Item Name: 205 Skidtube bent detail

DRAWING NO. D2580	TITLE 205 SKIDTUBE ASSEMBLY	REV. E	DART AEROSPACE LTD ENGINEERING ORDER	D.E.O. NO. D2580-E-1	SHEET NO. SHEET 1 OF 1	SCALE NTS
DRAWN <i>JP</i>	CHECKED <i>ASS</i>	MFG. APPR. <i>EC</i>	APPROVED <i>[Signature]</i>	DE APPR. <i>[Signature]</i>		
DATE 11.12.13	DATE 11.12.13	DATE 11.12.13	DATE 11.12.13	DATE 11.12.13

CHANGE ALL C'BORED WELDED CROSSBOLT SPACERS TO SWAGED SPACERS

SECTION B-B, F-F, I-I
NOT TO SCALE

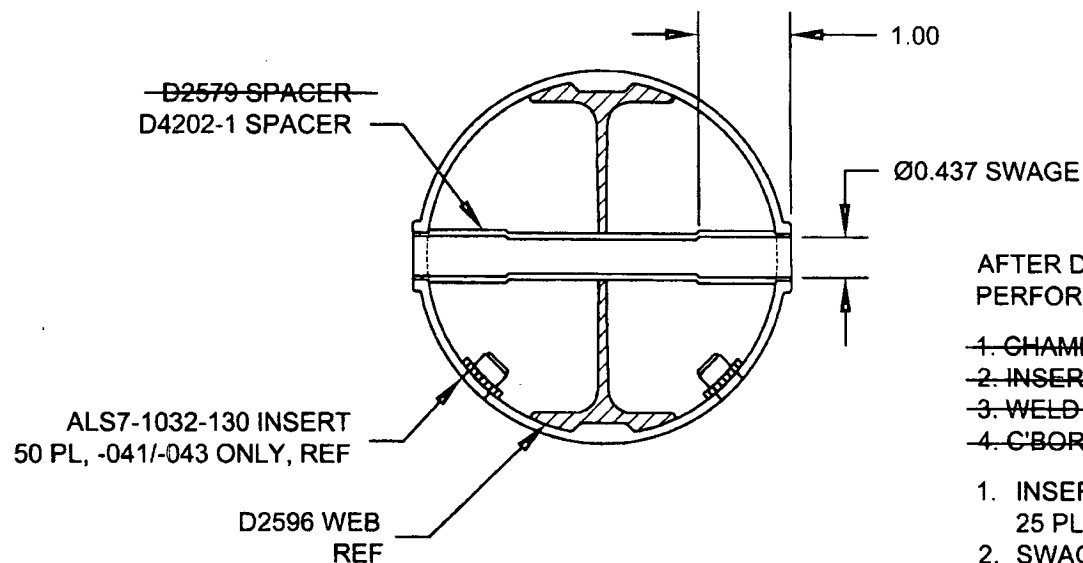
SECTION B-B, SECTION F-F, & SECTION I-I ARE AMENDED AS FOLLOWS
FOR ALL HOLES THAT WERE ORIGINALLY C'BORED:

WELD 4X D2579 SPACERS PER DWG
IN LOCATIONS MARKED "NO C'BORE".
REF SHEET 4 OF DWG.

- ~~1. CHAMFER HOLE 0.050 X 45°~~
- ~~2. INSERT D2579 SPACER (20 PLACES)~~
- ~~3. WELD INTO PLACE AND GRIND FLUSH~~
- ~~4. C'BORE D2579 SPACER TO Ø0.437 X 1.00 DEEP~~

1. INSERT D4202-1 SPACER, 20 PL (-041) OR 20 PL (-045) OR 25 PL (-047)
2. SWAGE TO Ø0.437 X 1.00 DEEP PER QSI 002
3. TRIM / GRIND FLUSH PER QSI 002
